MannKind Corporation

Re: Request for Additional Information - Termination of Mannkind Corp. License 06-30720-01

I am responding to your March 23, 2011 "Request for Additional Information" letter addressing Mannkind Corp. request to terminate our radioactive materials license.

Original Waste Room Configuration

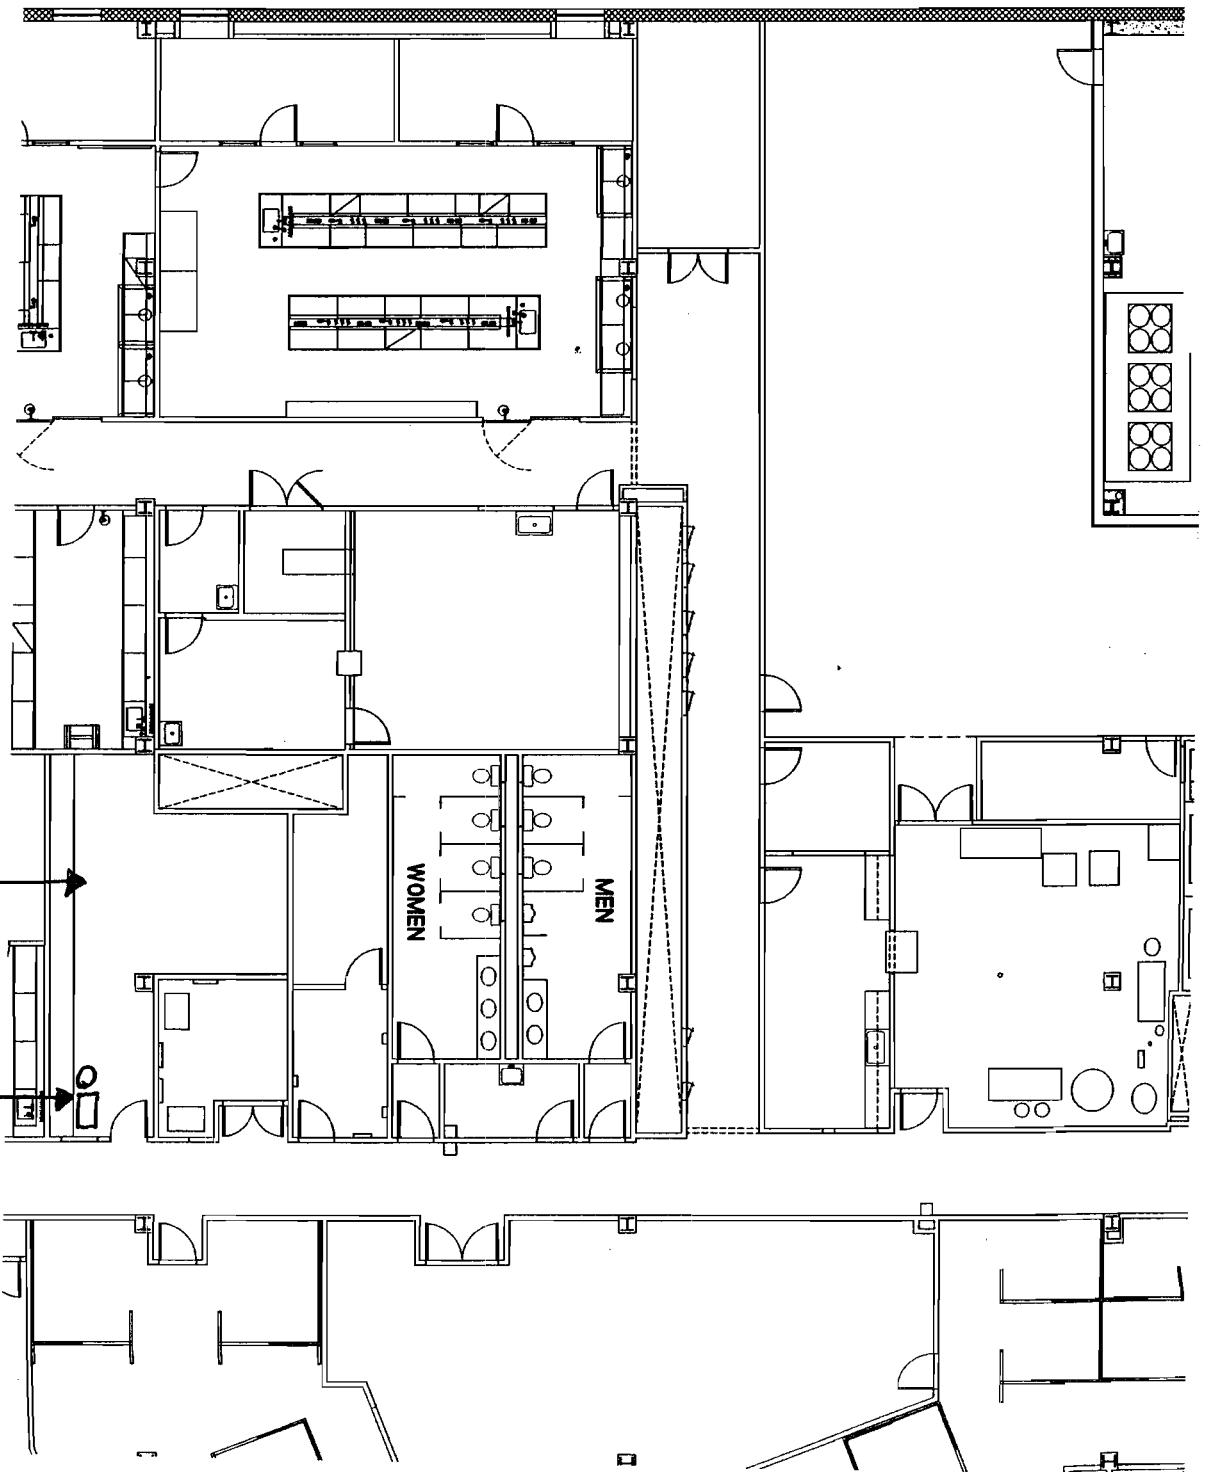
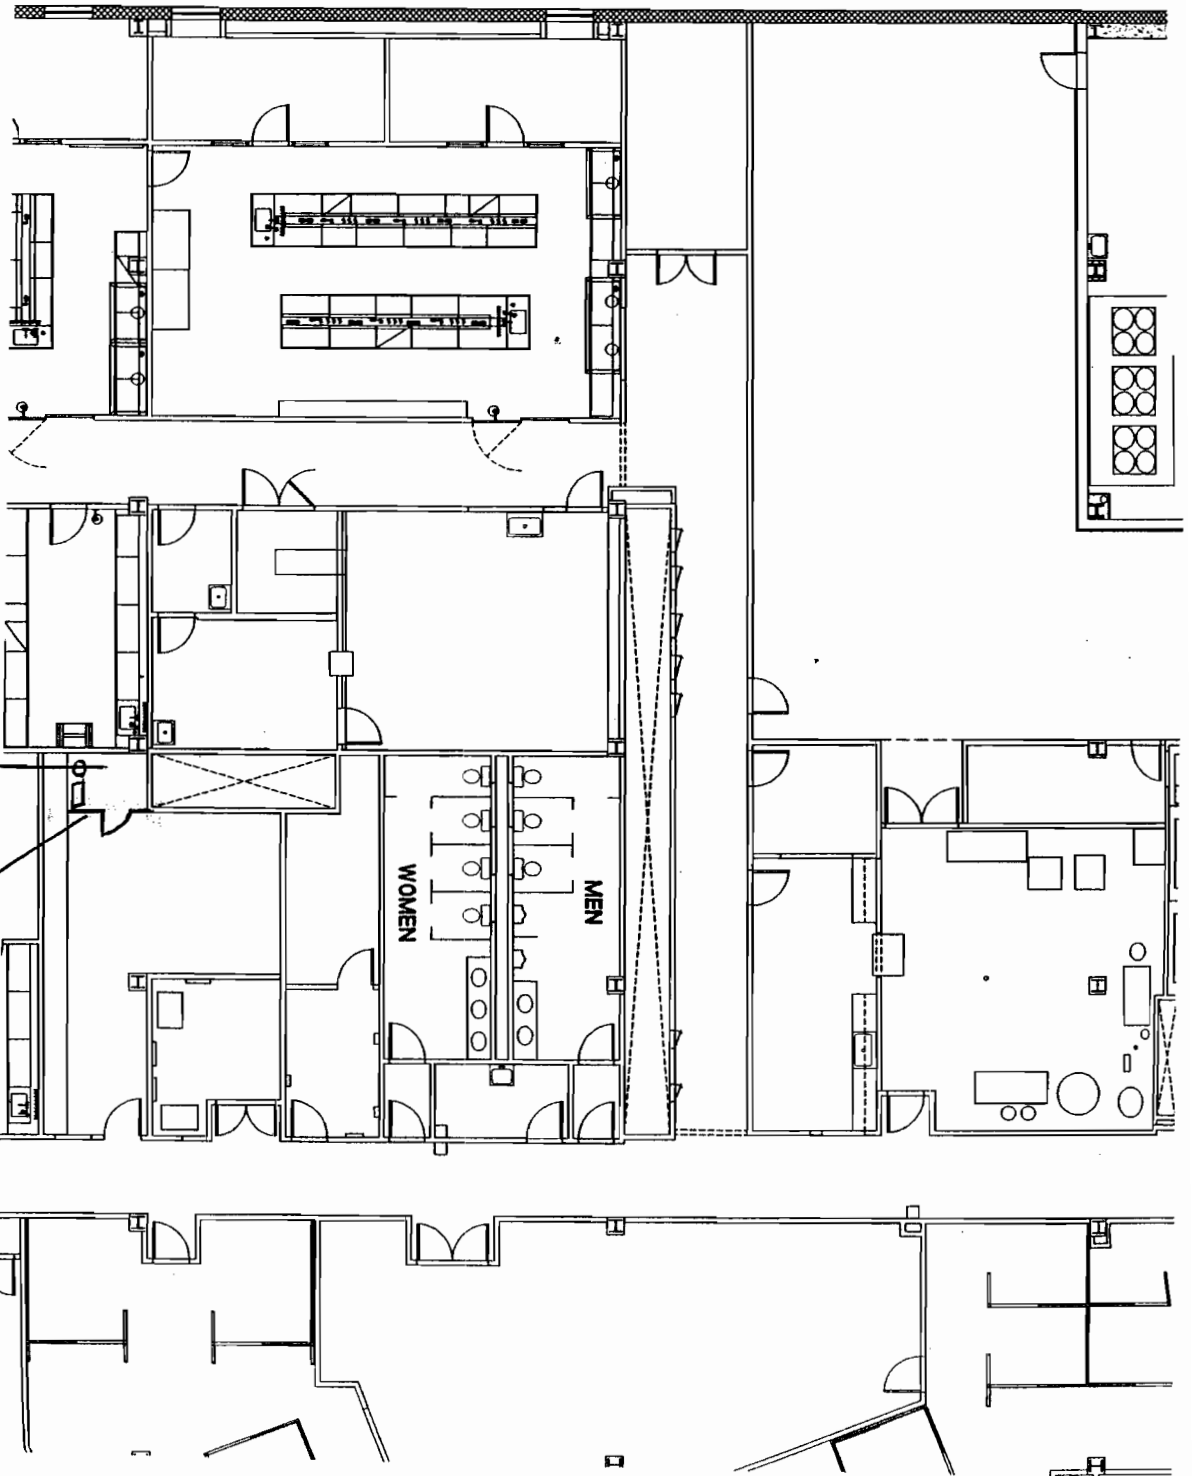
With the goal of making more efficient use of space at our facility we have reconfigured our waste room. MKC has completed the construction of a wall with a locking door creating an ancillary room within the original waste room. Please see the attached room diagram showing the placement of the new wall.

*New Waste Room Configuration
Addition of one wall with Locking door*

*New Wall
with locking door*
